South Coast 101 HOV Lanes Project

**Final Environmental Impact Report/Environmental Assessment
with Finding of No Significant Impact**

Appendix M

Prepared by the
State of California Department of Transportation

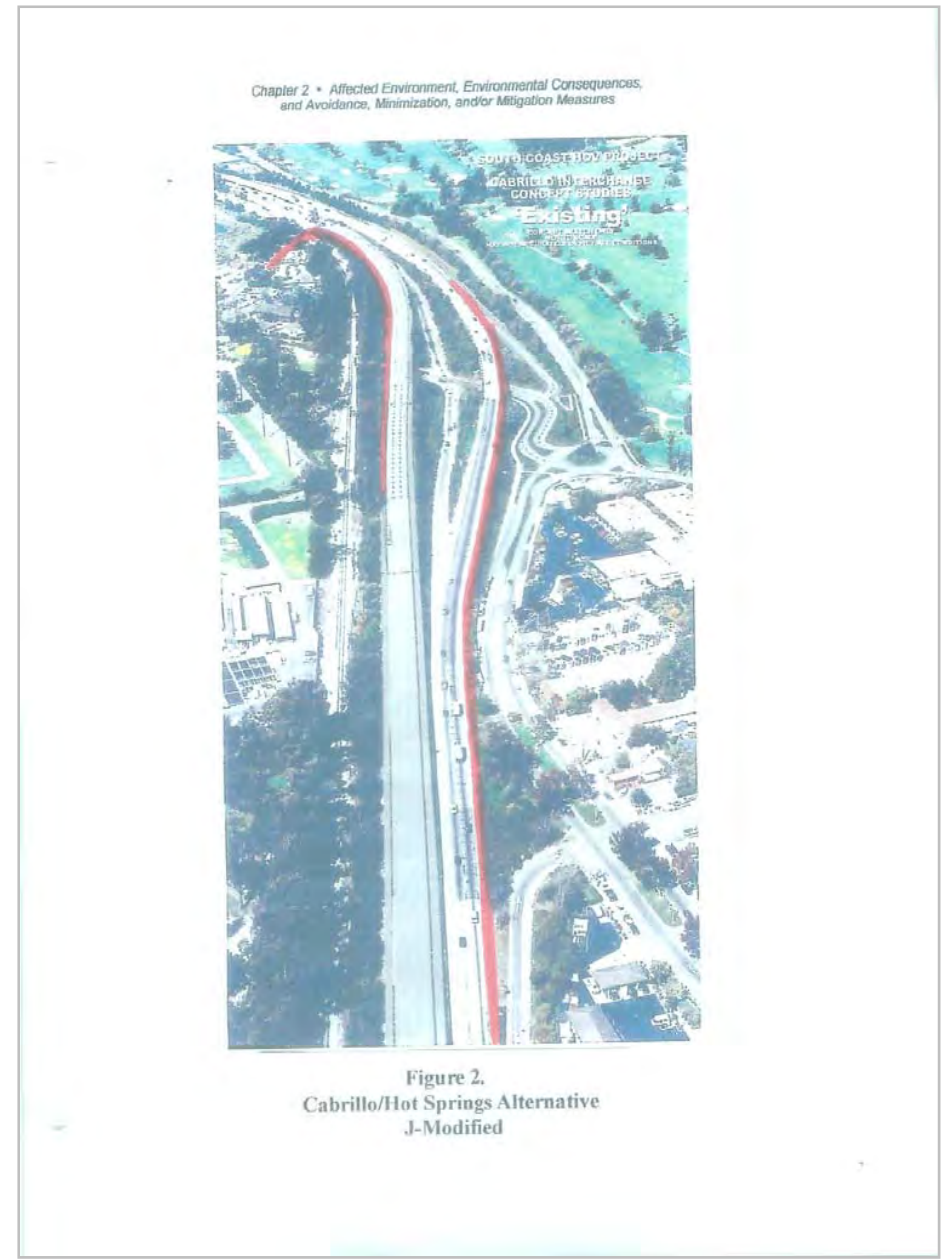
1. Alternative J Modified – This alternative is as described in the environmental document. Left-side off ramps and the Hermosillo off ramp would be maintained; a southbound on ramp would be added at Los Patos Way. See Figure 1. This alternative would retain the existing freeway overpasses in the current locations, minimize the amount of grading and thus maintain the existing aesthetics, reduce construction disruption, reduce construction duration and environmental impacts and dramatically reduce costs.

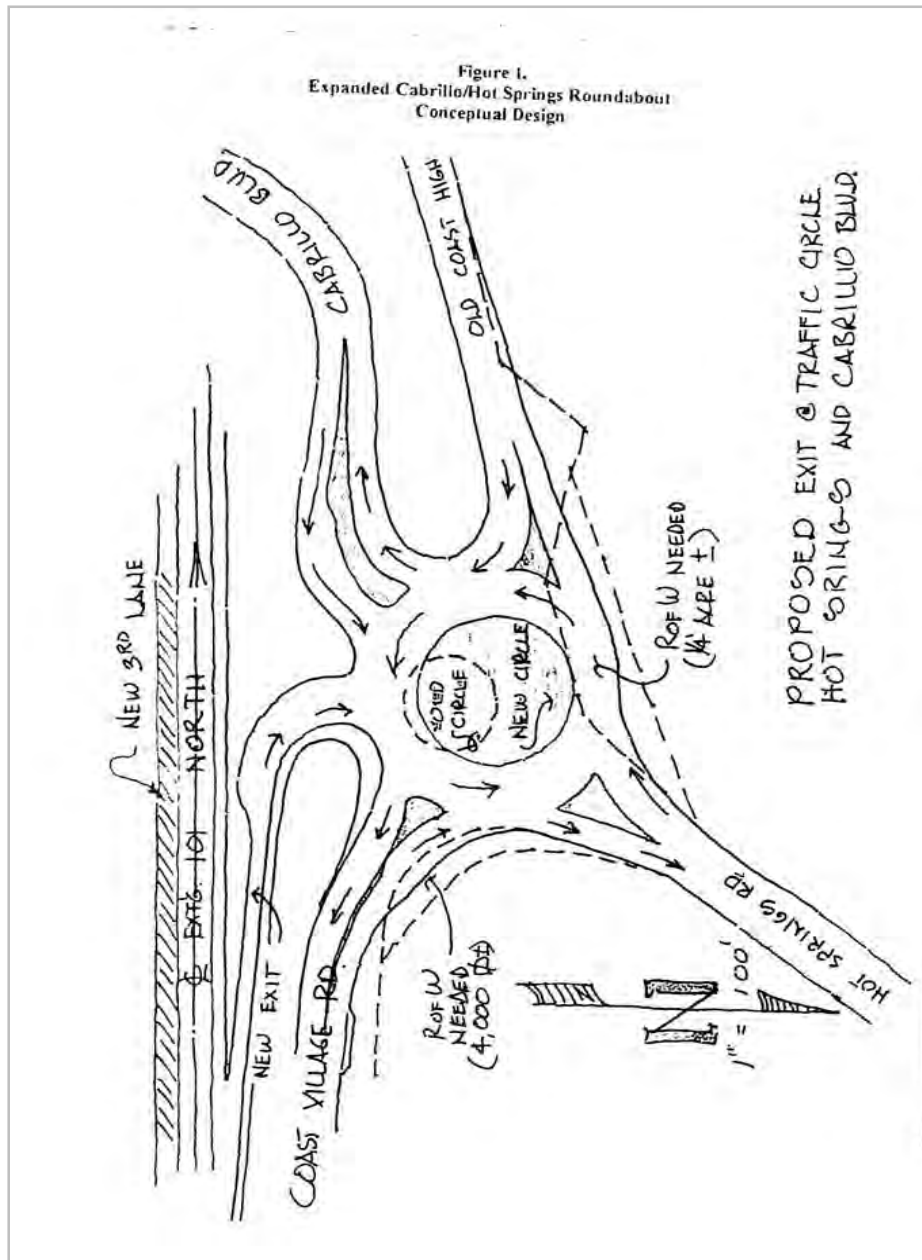
2. Northbound off ramp directly into expanded roundabout – See Figure 2. The Cabrillo/Hot Springs roundabout would be expanded to carry two lanes of traffic, requiring some right-of-way acquisition to the north. This alternative addresses the northbound off ramp only and does not address the southbound configuration.

Figure 3.
San Ysidro Interchange
Conceptual Design

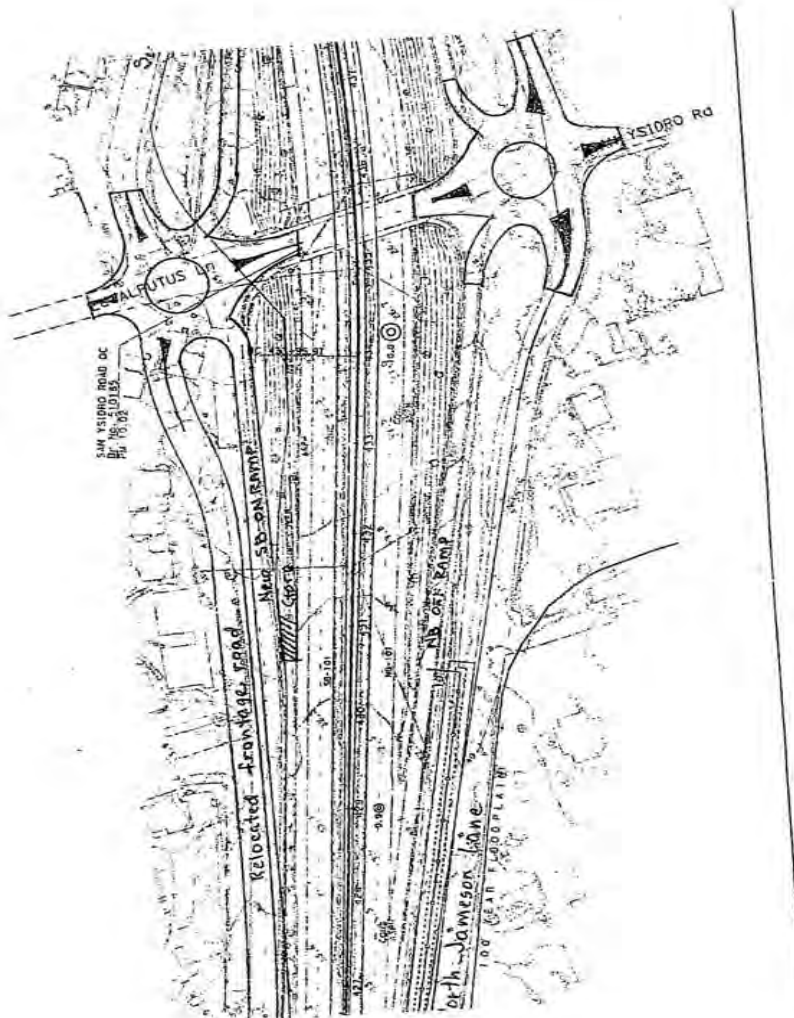
Improve overpass and improve southbound on ramp. One concept includes a new southbound on ramp and a roundabout at each end of the overpass as shown in Figure 3. This dumbbell arrangement would compensate for the inadequate overpass width, which has no provision for a left-turn lane.
